Intel[®] 82371AB PIIX4, Intel[®] 82371EB PIIX4E, Intel[®] 82371MB PIIX4M

Specification Update

January 2002

Document Number: **297738-017**

TD CONTROL AND STATUS (DWORD 1: 04-07h)

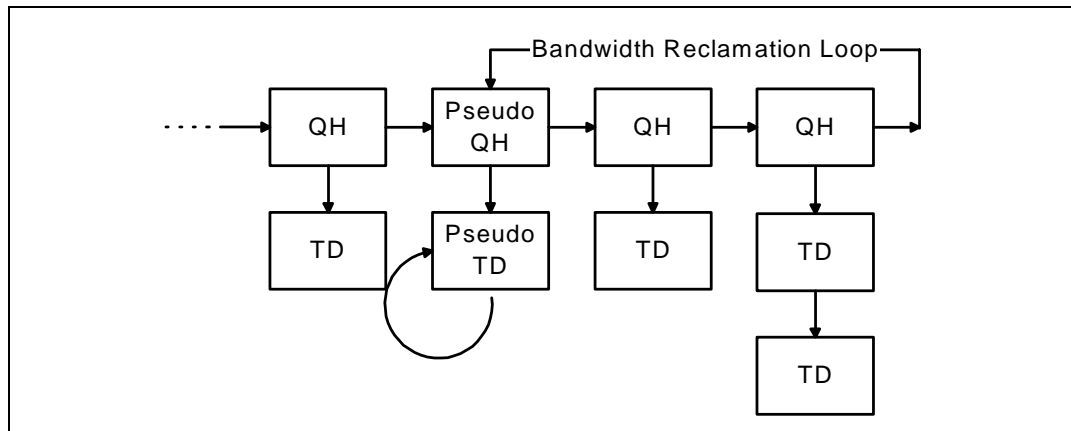
The Active status bit (bit 23) must be left unset at 0 indicating that the PIIX4/PIIX4E/PIIX4M should not execute this TD.

QUEUE HEAD LINK POINTER (DWORD 0: 00-03h)

The Queue Head Link Pointer (QHLP=bits [31:4]) must be set to point to the pseudo TD.
